CONNECTICUT SITING COUNCIL

RE: **DOCKET NO. 508** – The United Illuminating Company (UI) Certificate of Environmental Compatibility and Public Need for the Milvon to West River Railroad Transmission Line 115-kV Rebuild Project that consists of the relocation and rebuild of its existing 115-kilovolt (kV) electric transmission lines from the railroad catenary structures to new steel monopole structures and related modifications to facilitate interconnection of the rebuilt 115-kV electric transmission lines at UI's existing Milvon, Woodmont, Allings Crossing, Elmwest and West River substations along approximately 9.5 miles of the Connecticut Department of Transportation's Metro-North Railroad corridor traversing the municipalities of Milford, Orange, West Haven and New Haven, Connecticut. **Partial Development and Management Plan I Revision.**

Re: Docket No. 508 - The United Illuminating Company Application for a Certificate of Environmental Compatibility and Public Need for the Milvon to West River Railroad Transmission Line 115-kV Rebuild Project - Request for Modification to Structure Locations Near West River Substation

CITY OF WEST HAVEN
UI 115-kV RR PROJECT MILVON TO WEST RIVER
DEVELOPMENT & MANAGEMENT PLAN
SEGMENT 1

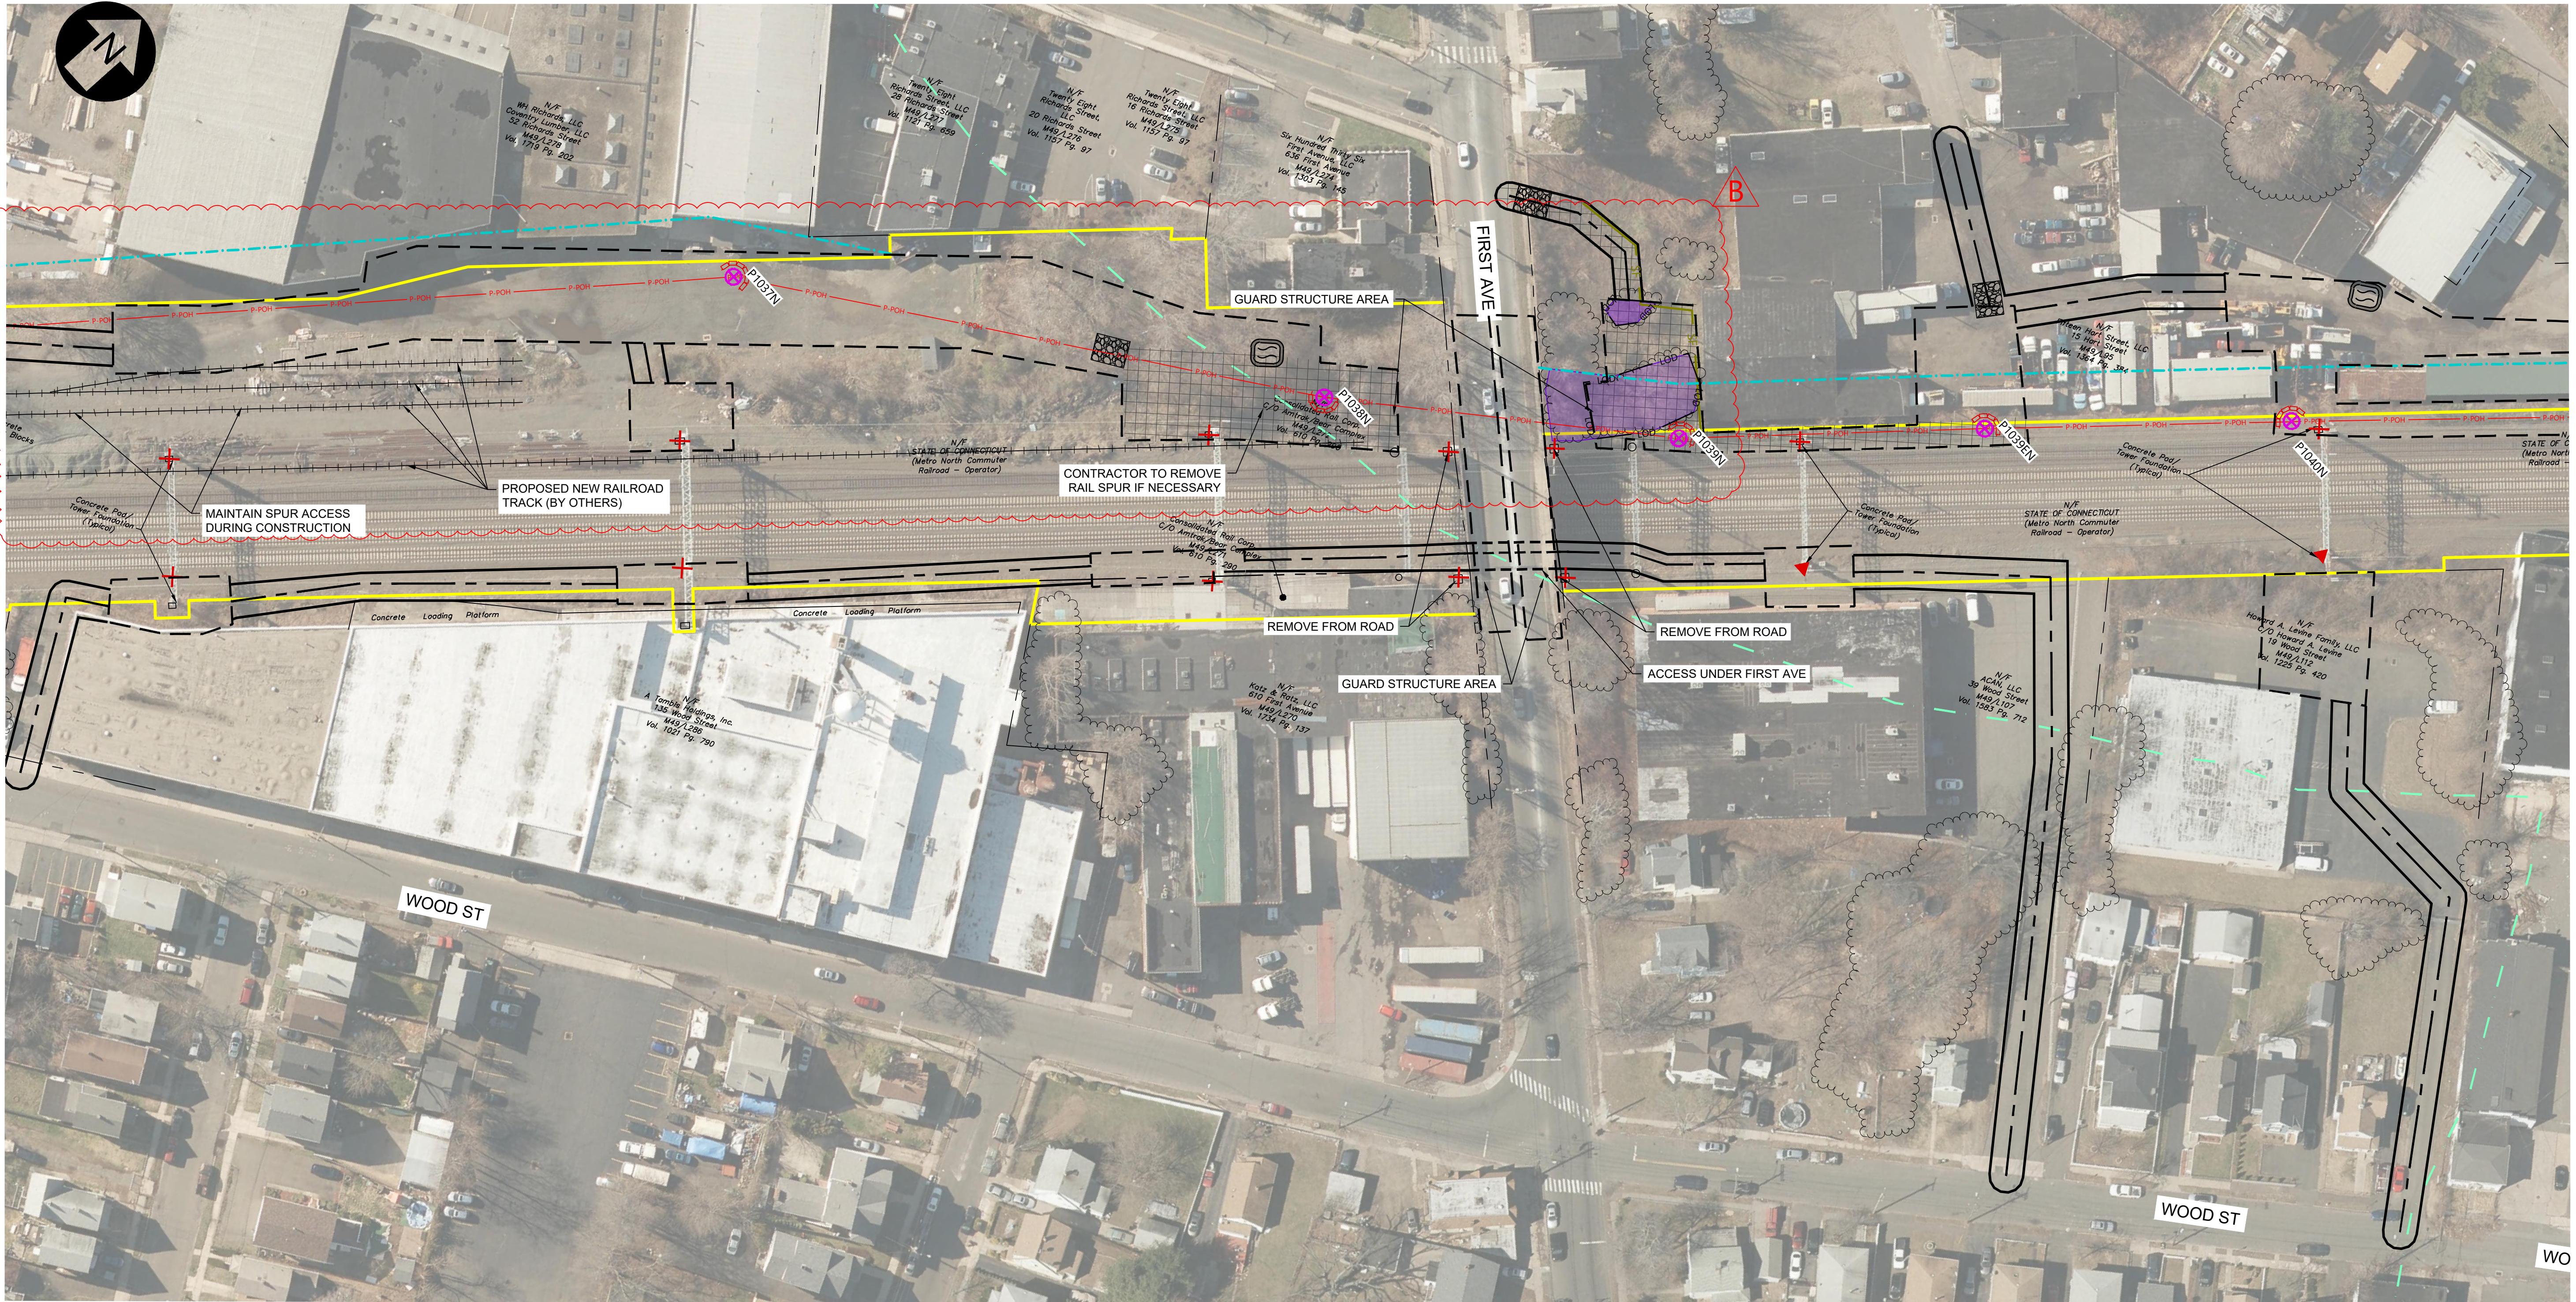
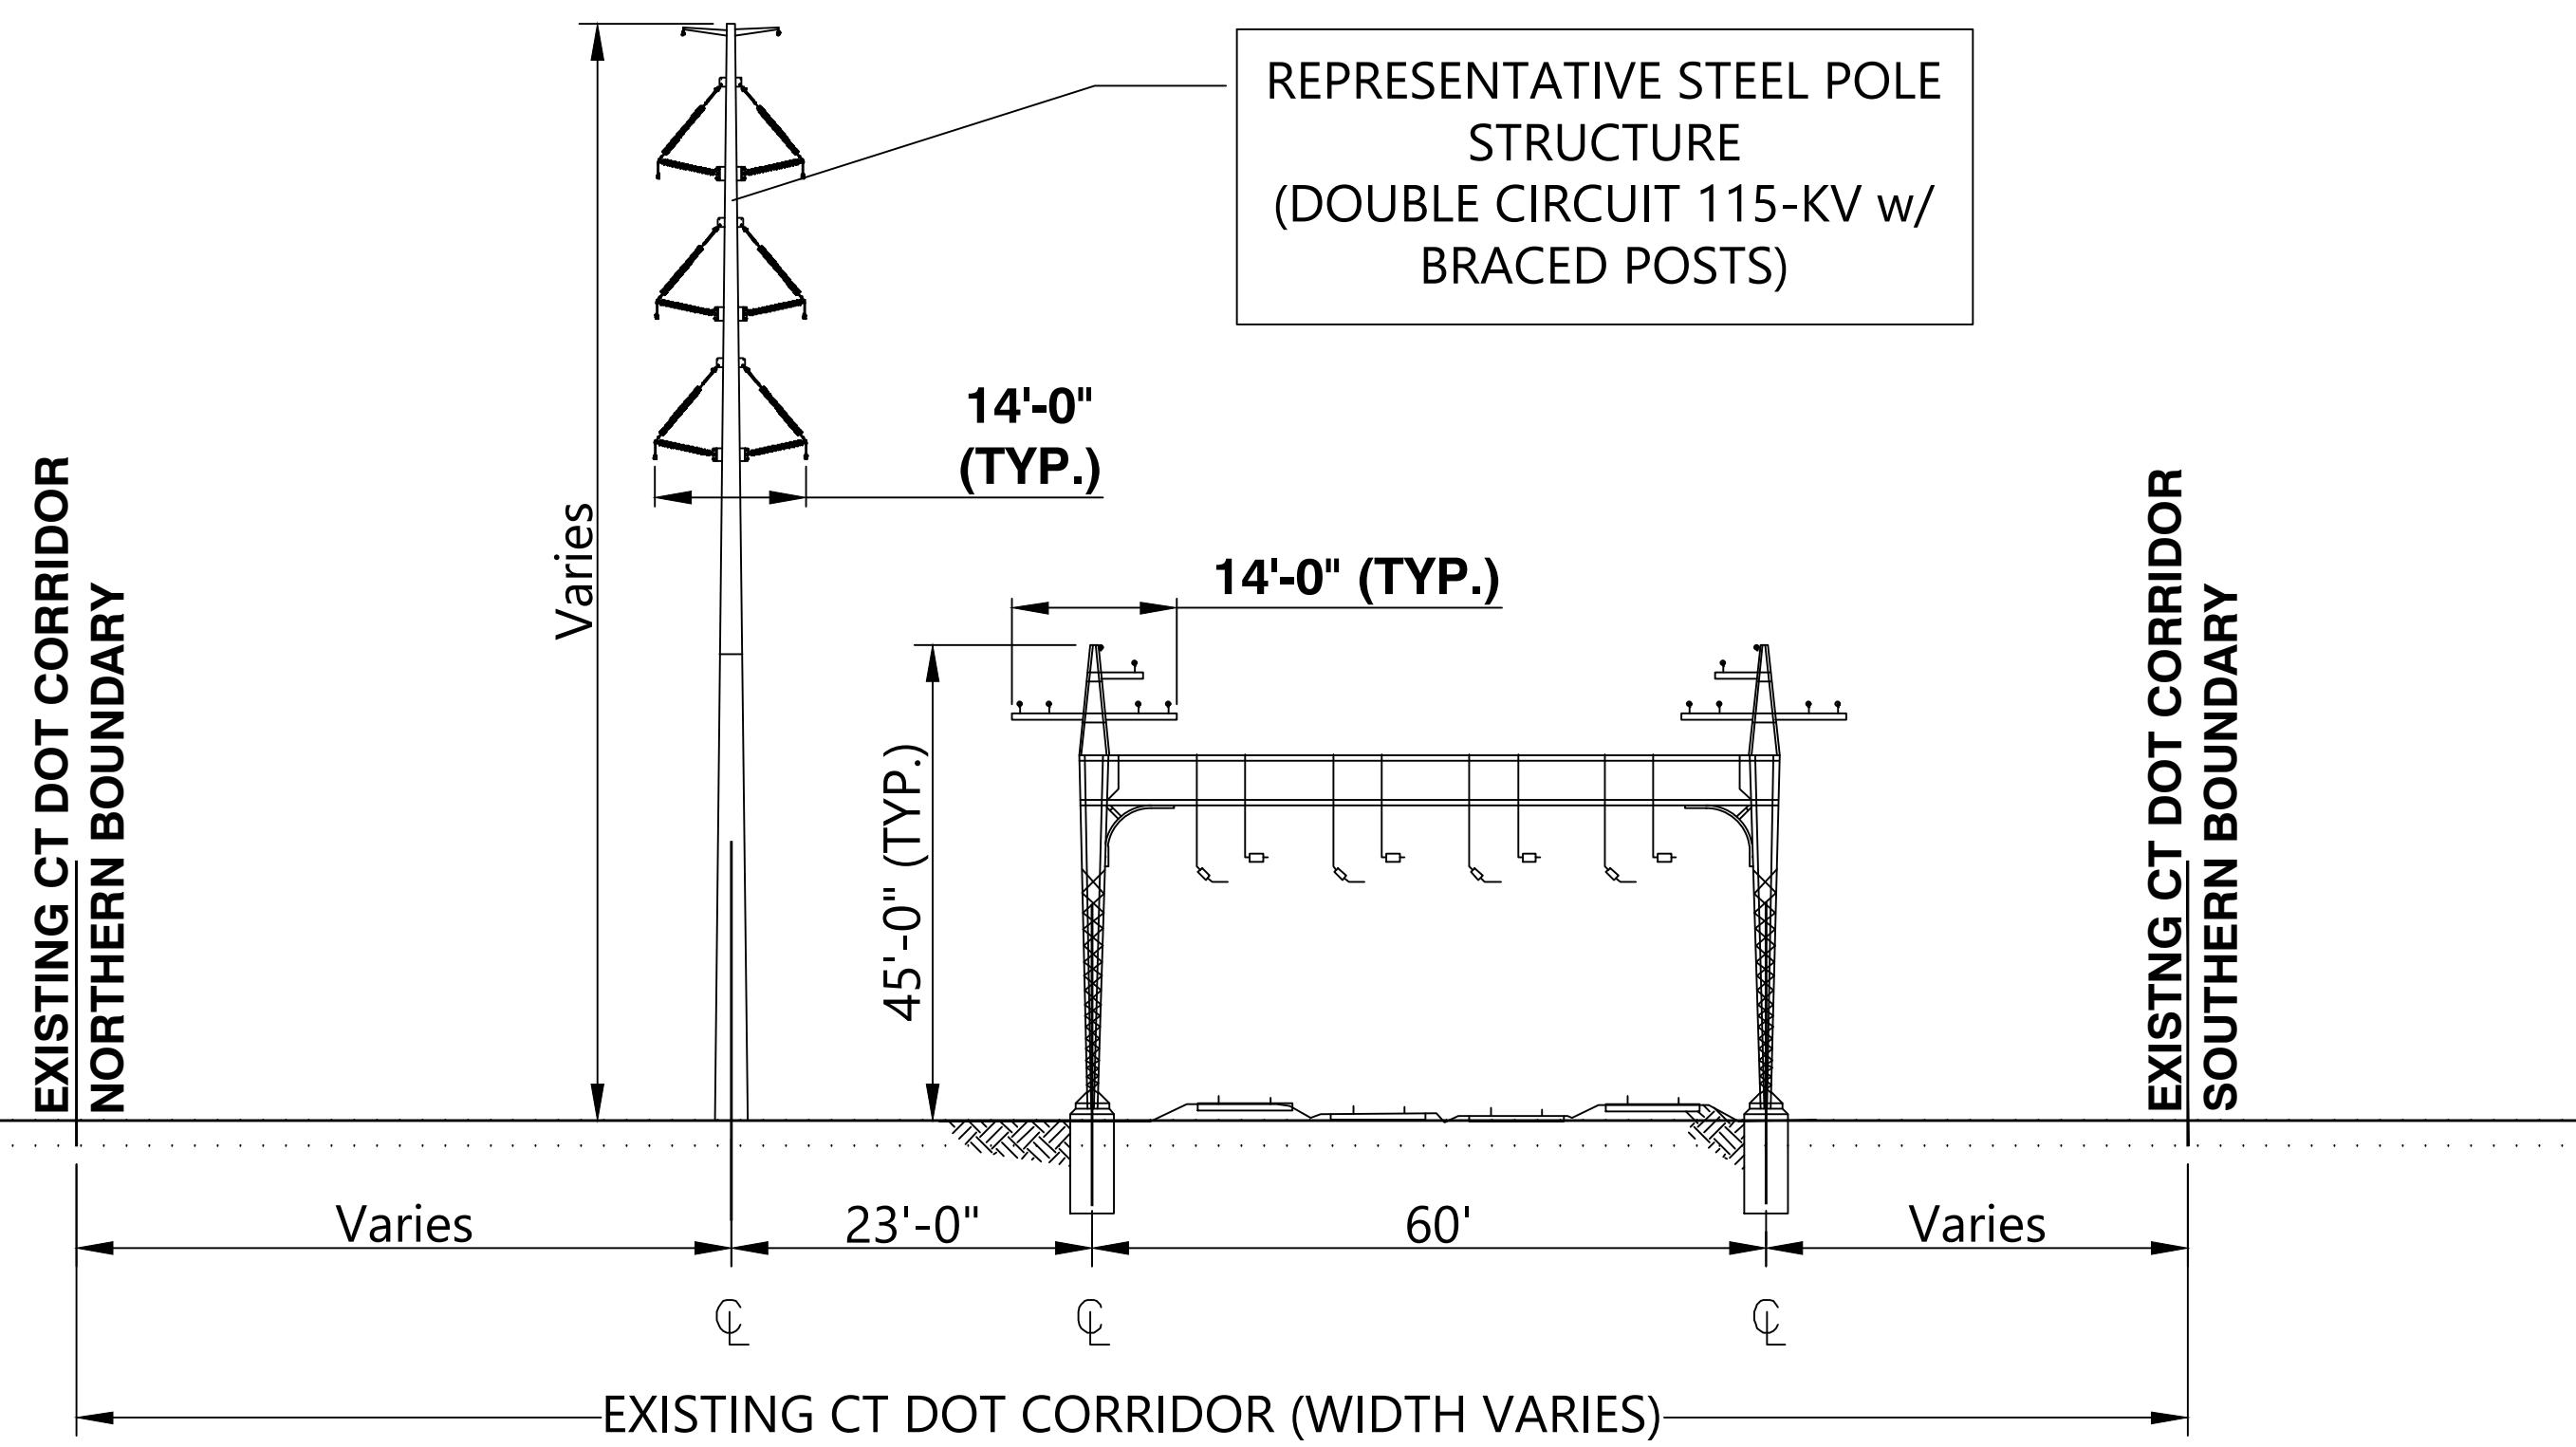
Structures P1035N and P1037N require an increase in height due to the increased span length and will be shifted farther north to accommodate future planned spur tracks and work areas for Metro-North Railroad and the Connecticut Department of Transportation.

- One of the double circuit steel monopoles originally planned for location along the north side of the MNR tracks in West Haven will be eliminated.
- Structures P1035N and P1037N will increase in height (to 120 and 125 feet, respectively) because of increased span length due to the elimination of P1036N and to maintain required vertical clearances for an adjacent building. These two structures were shifted farther north to accommodate the future planned spur tracks and work areas for MNR and CDOT.
- The realignment of P1035N and P1037N to the northern edge of the CDOT property will require easements on adjacent private properties, which will result in an additional 0.34 acre of permanent easements for the Project.

STRUCTURE NO.	STRUCTURE TYPE	CROSS SECTION	HEIGHT (FT)	FOUNDATION
P1037N	DEADEND	XS-12	121	CONCRETE DRILLED PIER
P1038N	TANGENT	XS-13	126	CONCRETE DRILLED PIER
P1039N	TANGENT	N/A*	131	CONCRETE DRILLED PIER
P1039EN	TANGENT	N/A*	131.5	CONCRETE DRILLED PIER
P1040N	TANGENT	N/A*	131	CONCRETE DRILLED PIER
